Access Compliance Report

Public Rights-of-Way

(Curb Ramps)

Intersection ID: 11049	Main Street: MALTA_PL	Cross Street: OAK_FOREST_DR	Location: SE
ADA ID: 0176F0926BDD	Ramp Type: Perp	Initial Pass/Fail: Fail	Overall Compliance: No
Severity Score: 8.75			
Codes/Mitigation Info/Possible Solution		Field Measurements/Component Compliance

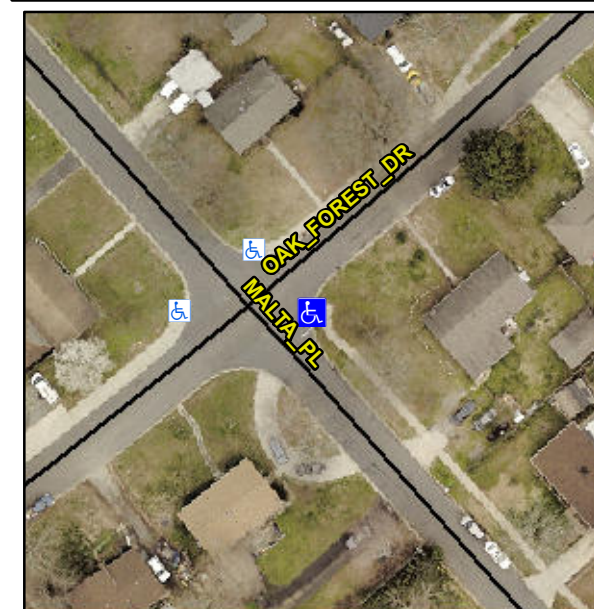
Not Found, R304.5.1

Compliance	Description	Data	Compliance	Description	Data
N/A	Ramp Length (in)	47.0	Yes	Ramp Slope (%)	5.0
No	Ramp Width (in)	45.5	Yes	Ramp XSlope (%)	0.2
N/A	Flare Type LT	N/A	N/A	Flare Type RT	N/A
N/A	Flare Slope LT (%)	N/A	N/A	Flare Slope RT (%)	N/A
N/A	Flare Traversable LT?	N/A	N/A	Flare Traversable RT?	N/A
N/A	Landing Length (in)	N/A	N/A	DWS Provided?	N/A
N/A	Landing Width (in)	N/A	N/A	DWS Contrast?	N/A
N/A	Landing Slope (%)	N/A	N/A	DWS Length (in)	N/A
N/A	Landing X Slope (%)	N/A	N/A	DWS Full Width?	N/A
N/A	Landing Curb? (Y/N)	N/A	N/A	DWS Offset (in)	N/A
N/A	Shared Landing?	N/A			
N/A	Gutter Ponding?	N/A	N/A	Gutter Slope (%)	N/A
N/A	Gutter Lip Ht (in)	N/A	N/A	Gutter X Slope (%)	N/A
N/A	Painted X Walk1?	No	N/A	Painted X Walk2?	N/A
	X Walk 1 Direction	To NW		X Walk 2 Direction	N/A
N/A	X Walk 1 Width (in)	N/A	N/A	X Walk 2 Width (in)	N/A
	X Walk 1 Slope (%)	1.4		X Walk 2 Slope (%)	N/A
	X Walk 1 X Slope (%)	2.3		X Walk 2 X Slope (%)	N/A

Remove & Replace Entire Ramp.
